**ADDENDUM NO. 4**

PROJECT: Lake Ouachita Water Supply Project  
Contract 3 – Raw Water Transmission Pipeline (REBID)  
Hot Springs, Arkansas

CITY OF HOT SPRINGS UTILITY DEPARTMENT  
LAKE OUACHITA WATER SUPPLY PROJECT  
RAW WATER TRANSMISSION PIPELINE  
WATER LINE BEDDING FOR DUCTILE IRON

## DUCTILE IRON WATER LINE BEDDING

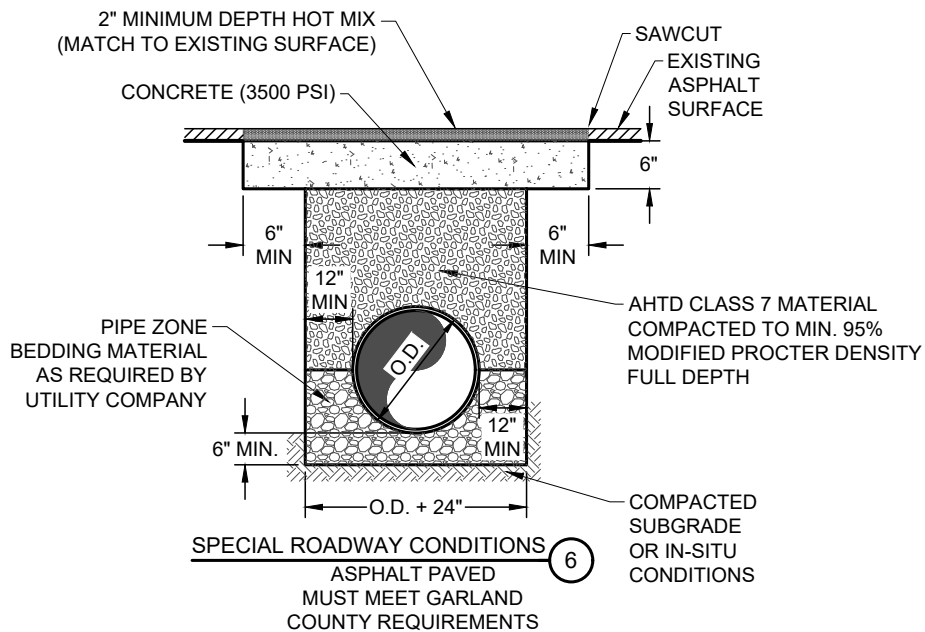
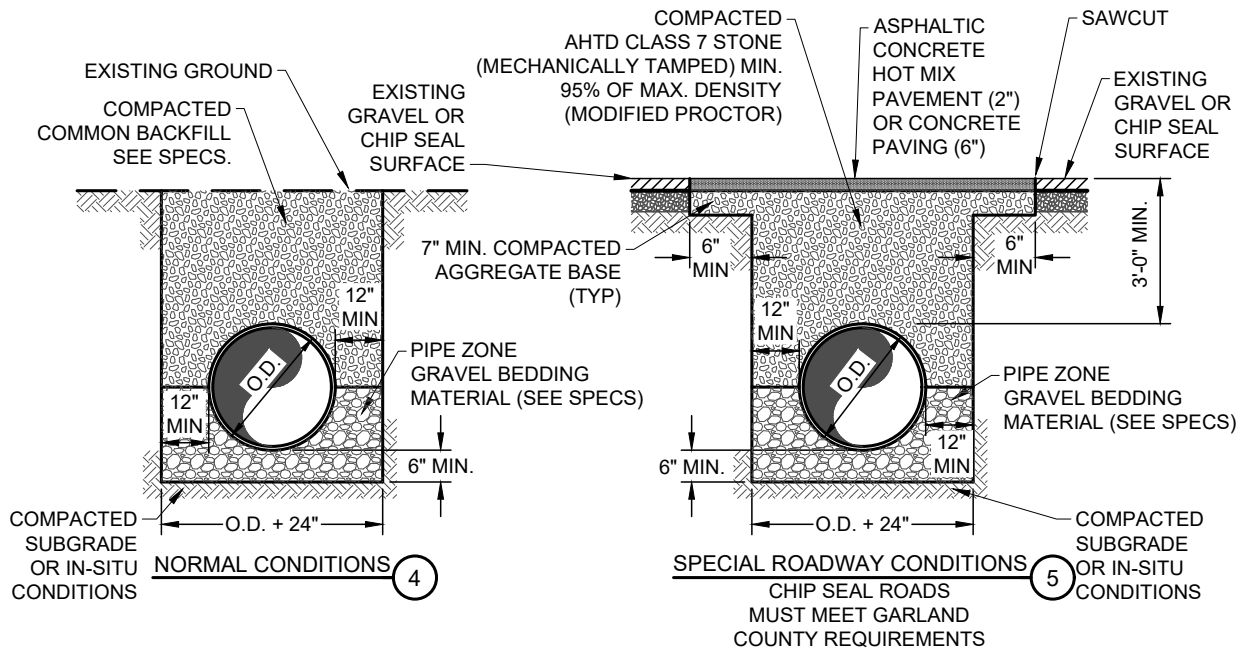
- a. Change Water Line Bedding Details B.1, B.2. and B.3 to be for Steel Pipe Only. Bedding Material shown on the details are defined as the “Pipe Zone” (not re-issued).
- b. On Details B.1 and B.3 the gravel bedding extends 6 inches above the pipe.
- c. On Detail B.3. strike “Crushed Rock (3/8”-1 ½” Max) or” from the note for backfill above the pipe zone (not re-issued).
- d. Add Water Line Bedding Details B.4, B.5, and B.6 for Ductile Iron Pipe, with changes summarized as follows (See attached):
  - Pipe zone backfill (gravel) material to springline of pipe,
  - Non-roadways to have common fill above springline, and
  - Roadways to have AHTD Class 7 backfill above springline.
